ARINC 424 NDB

**Draft 1 of Supplement 23
Discussion/Proposal**

CODING FD LEG DISTANCES WITH TURN ANTICIPATION REQUIRED

SUMMARY
Discussion of adding detail to Attachment 5 section 3.6 regarding turn anticipation as required by IAP notes and use of FD path terminators. Discuss proposal of distance coding tolerances when FD legs used as course reversal legs from a navaid to CF legs

INSTRUMENT APPROACH CHART

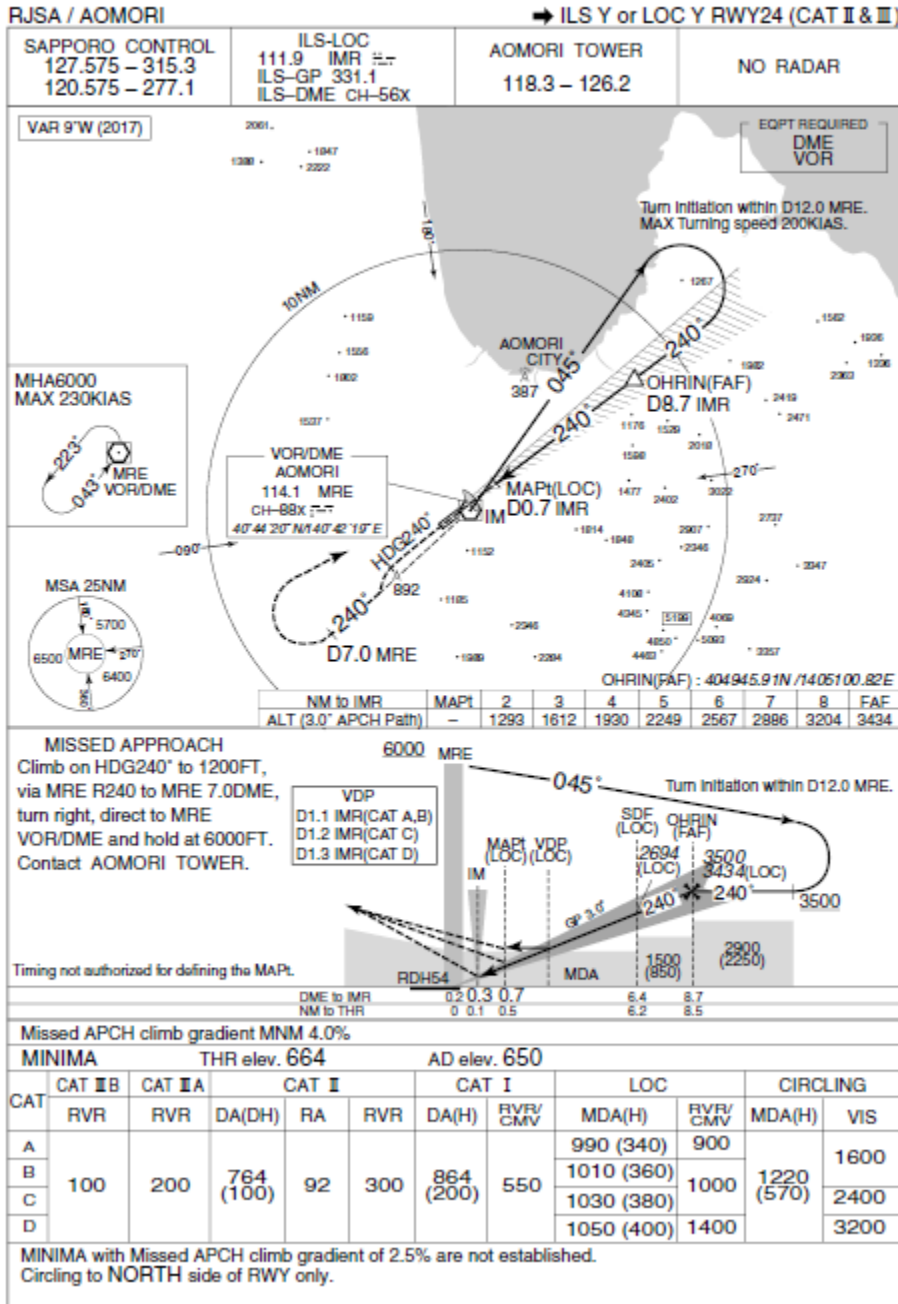
Instrument Approach Procedure (IAP) chart notes in some cases may include
“Turn Initiation within D xx.x ...”

FD legs are used as applicable path terminators on Instrument Procedure coding where a course reversal tear-drop like maneuverer is required. Typically this is an outbound track to a distance from a VHF navaid and greater than 180 degree course reversal to a CF leg to the inbound final approach course. Turn anticipation is unknown to PBN systems and the use of FD leg termination point is overfly. FD leg distance coding can be subjective and may not be sufficient at the set distance coding to comply with turn anticipation See example of RJSA where turn anticipation is required within 12.0nm of MRE navaid when using MRE as the IAP transition.

Propose to include clear coding rule text in Appendix 5 section 3.6 with use of FD path terminator distance tolerances. The new text accounts for FD leg is used used on IAP as an outbound course from a fix followed by next leg is the final approach course inbound. Common nomenclature is known as a “tear drop maneuverer” but not as a procedure turn leg (PI).

- 3.6 Leg types of CD, CR, FD, VD, and VR overfly the terminator point. ~~If turn anticipation is required to reflect the source, alternate leg types must be used.~~ *FD path terminator distance must consider turn initiation distance when noted on Instrument terminal procedure charts where FD leg is appropriate path terminator for course reversal to the final approach inbound course and PI leg is not intended. The nominal distance used for FD path terminators when used for course reversal and turn initiation distance limit is charted should be coded at an abeam distance point of the next fix after FD leg with 2nm pad and always less than the charted turn initiation distance. If coding of set distance is not possible, alternate leg types must be used.*
